January 20, 2009

Subject: CEQA Scoping Meeting, Proposed Septic Prohibition in the Malibu Civic Center Area (Public Notice No. 08-061) - Comments on Groundwater Basins in the Winter Canyon and Civic Center (Malibu Creek) Areas

Figure 1

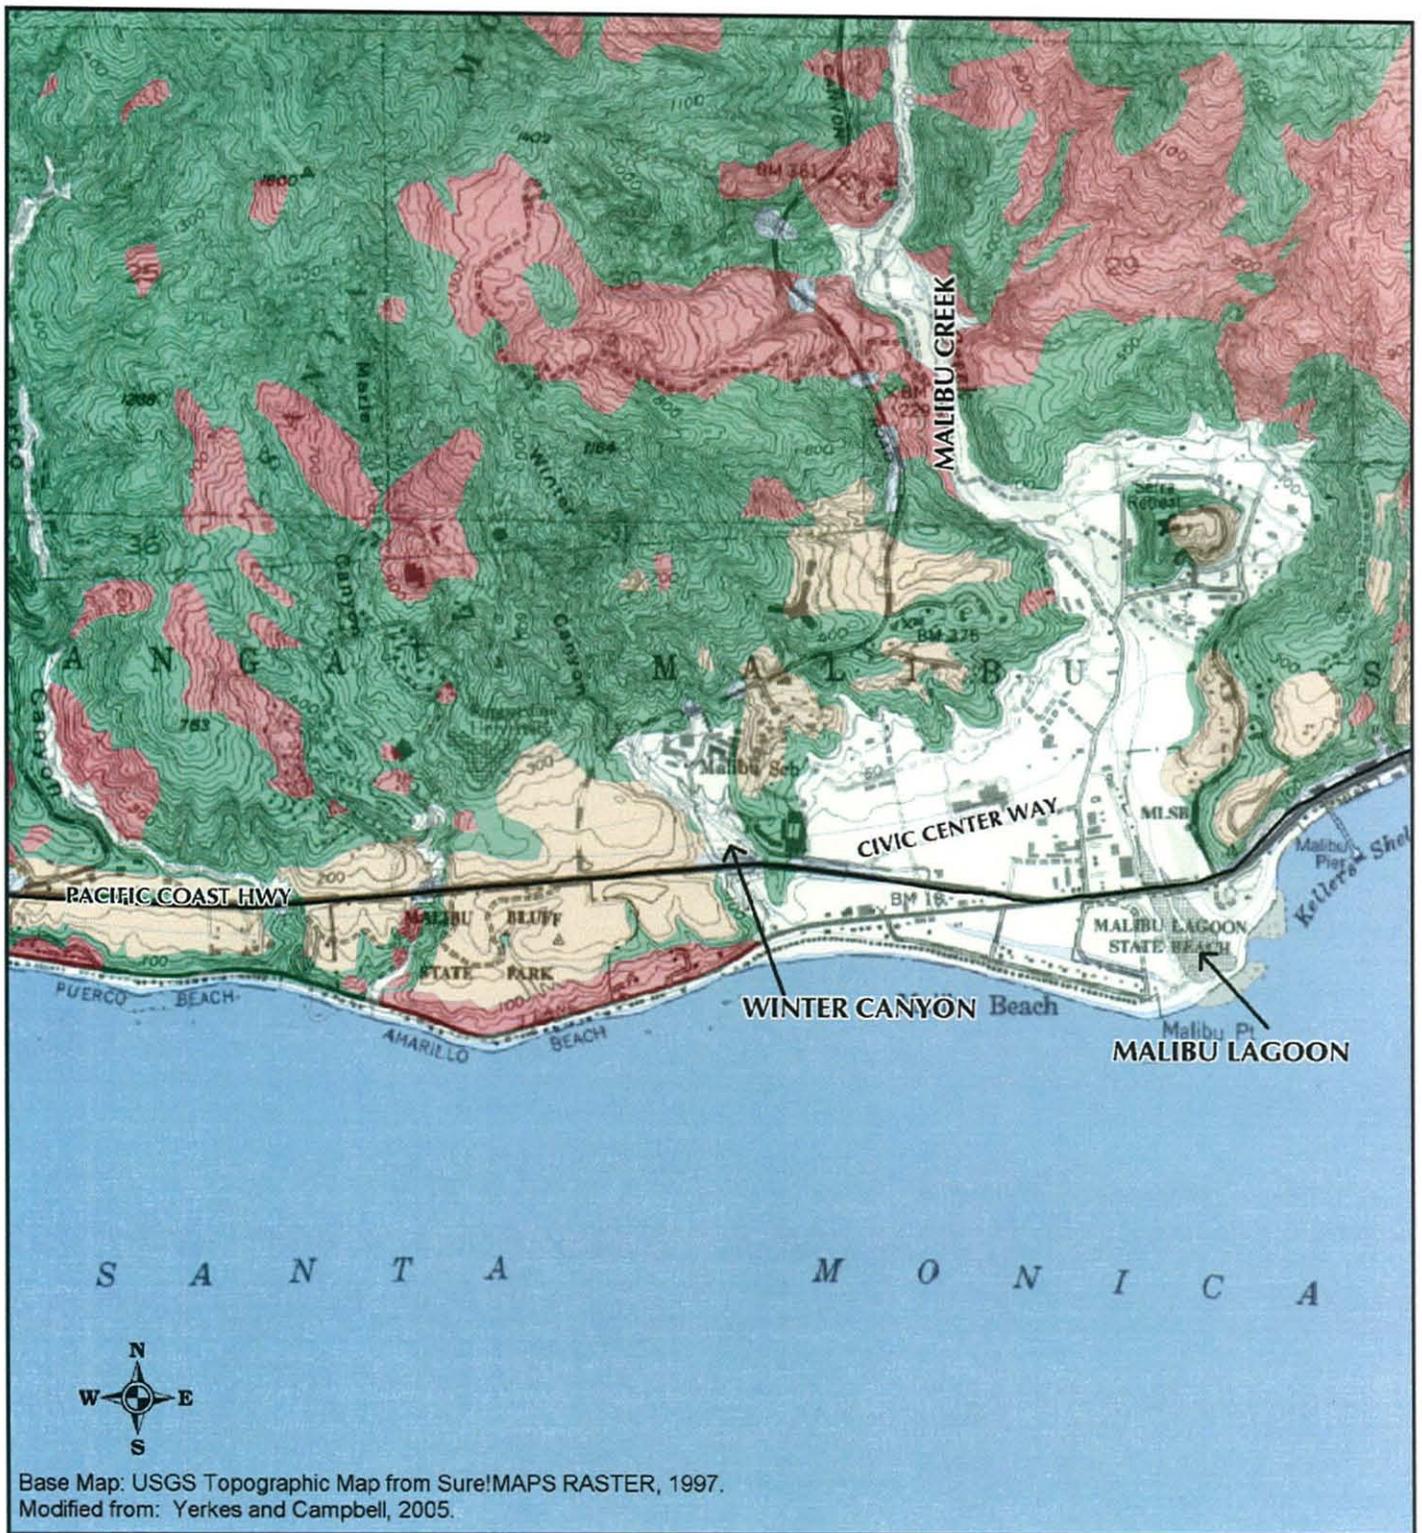
Winter Canyon and Malibu Creek are separate watersheds. Although they are adjacent, an intervening ridge divides surface waters such that each watershed drains independently towards the ocean. The ridge is composed of siltstone bedrock of the Monterey Formation, which is partially capped by Quaternary terrace deposits (see Figure 1).

Figure 2

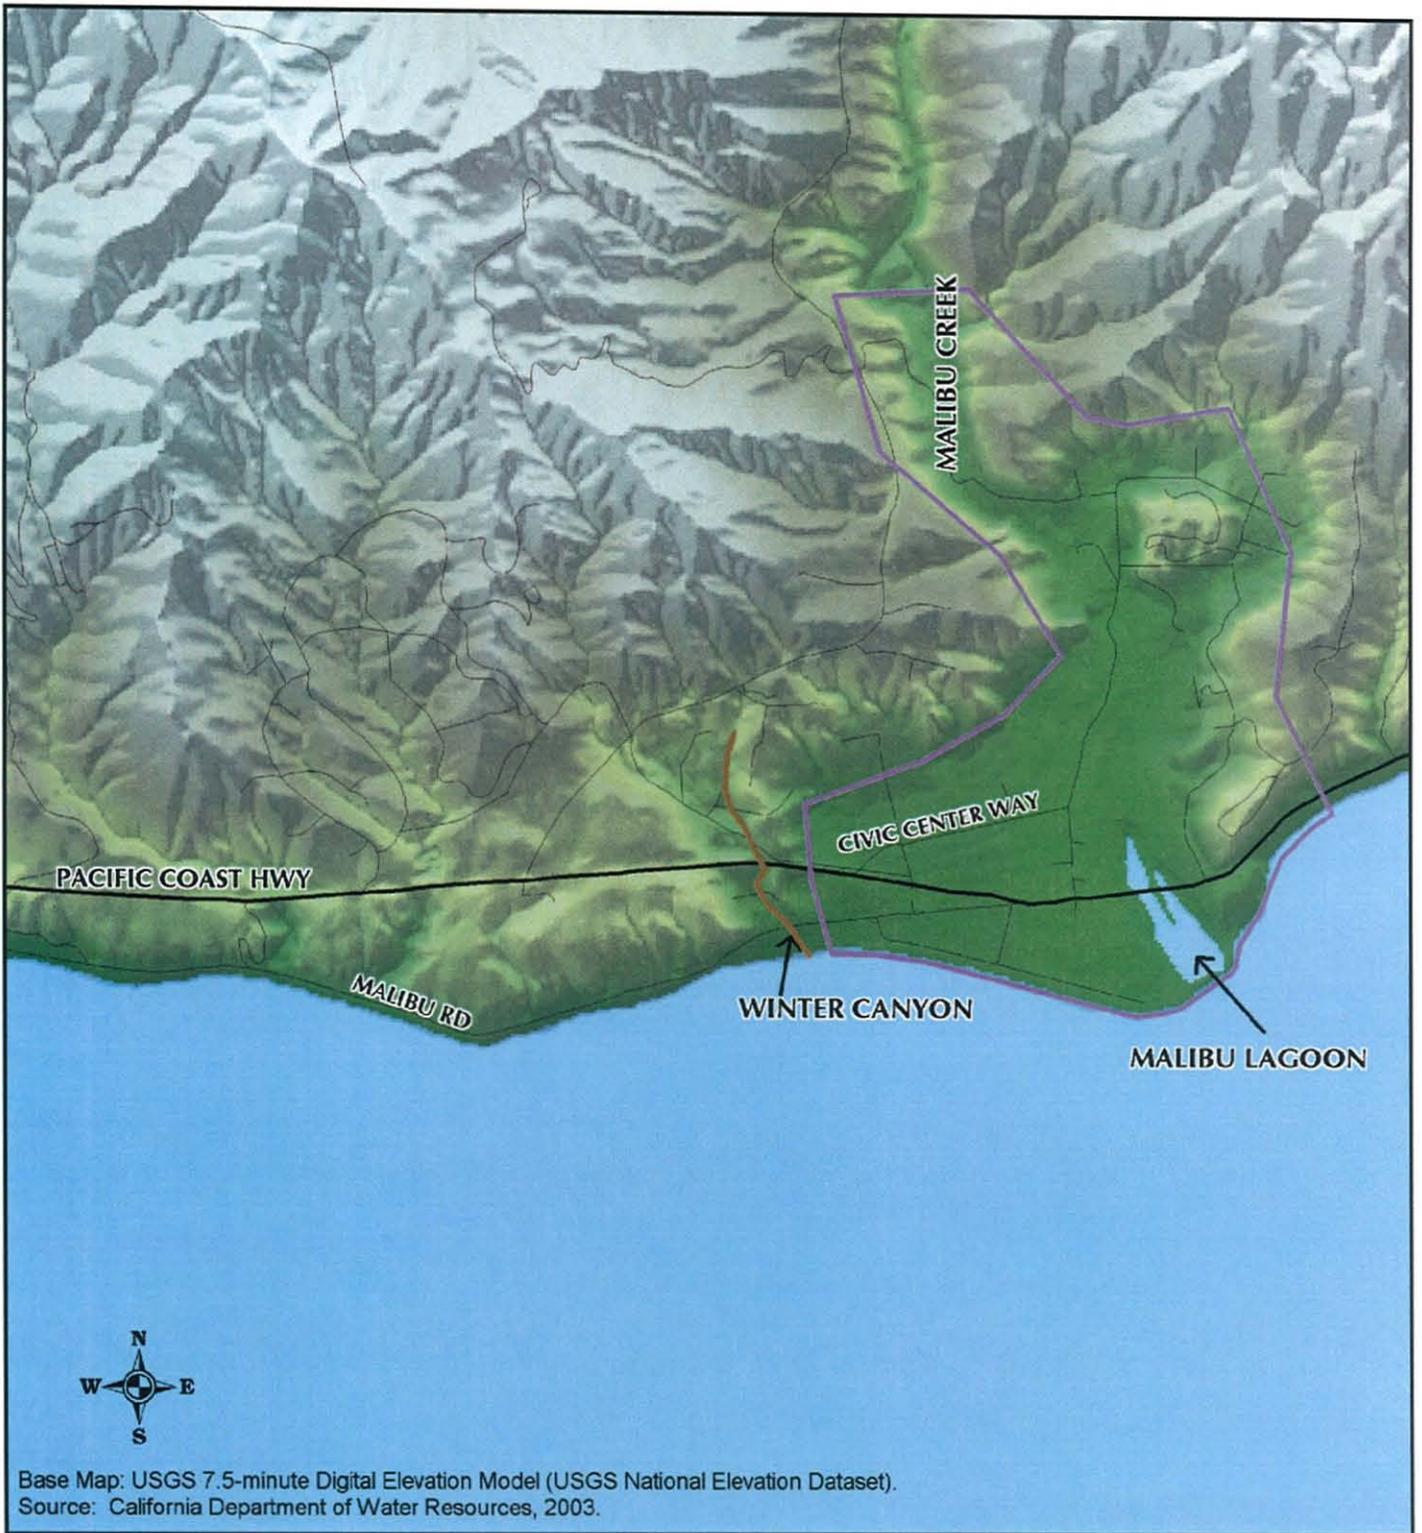
The DWR boundaries of the Malibu Valley Groundwater Basin, shown on Figure 2, do not include Winter Canyon.

Figure 4

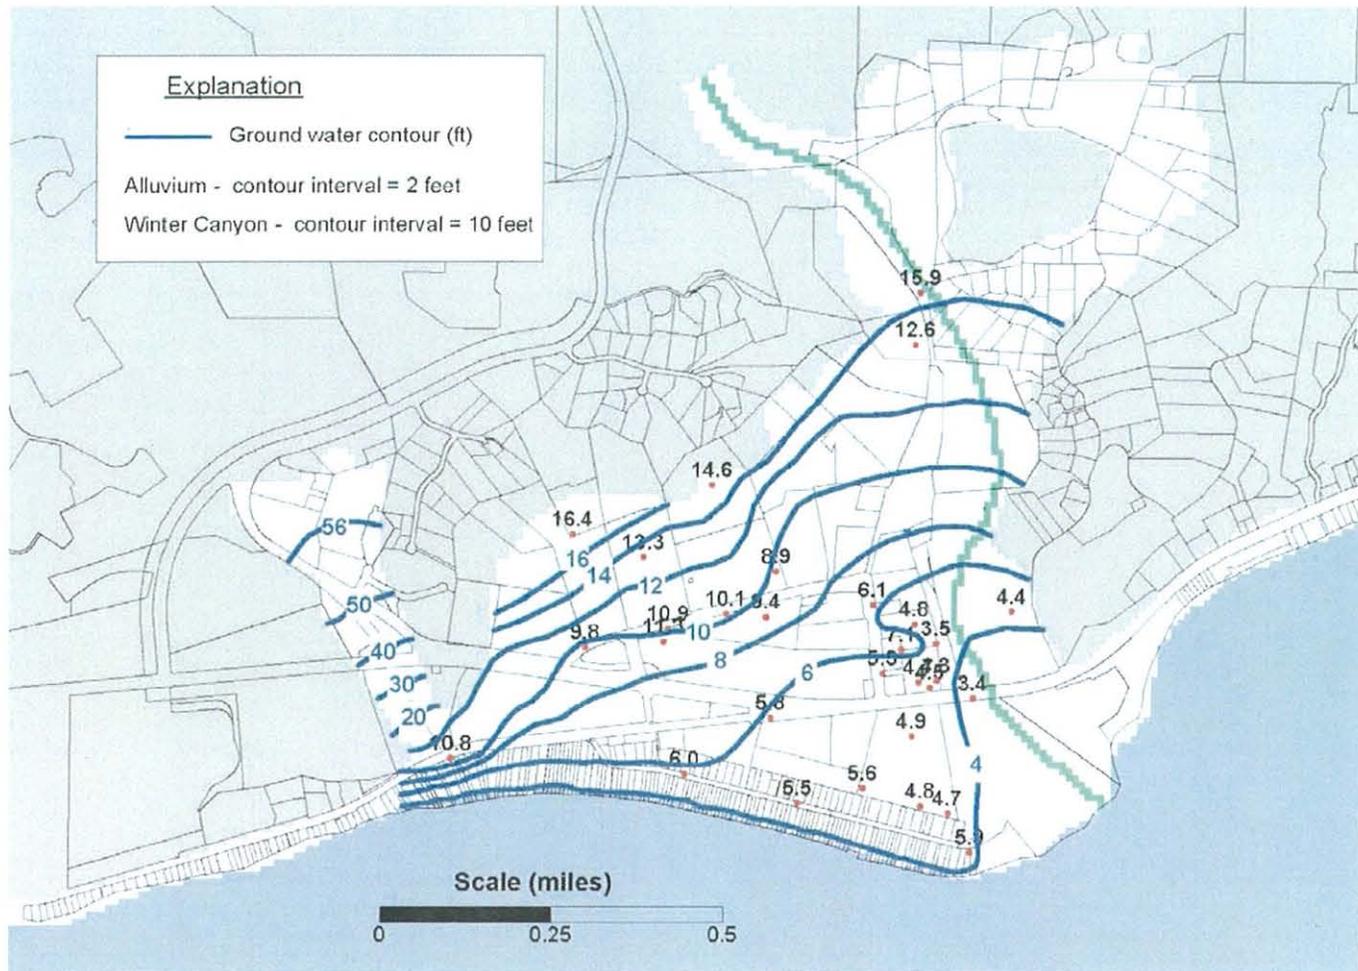
The lack of hydraulic connectivity between Winter Canyon and the Civic Center area is further illustrated in Figures 3 and 4, reproduced from Stone Environmental, Inc. (2004). Water levels measured during September 2003 (unbreached lagoon) and during March 2004 (breached lagoon) show:

- The two areas are very different with respect to water level and flow gradient.
- Neither system flows into the other – the only location where mixing of the waters might occur is south of Malibu Road, at the ocean/groundwater interface.
- Although flow patterns in the Malibu Creek/Civic Center area are altered significantly by changes in the lagoon's exposure to the ocean, Winter Canyon's water levels are not affected.
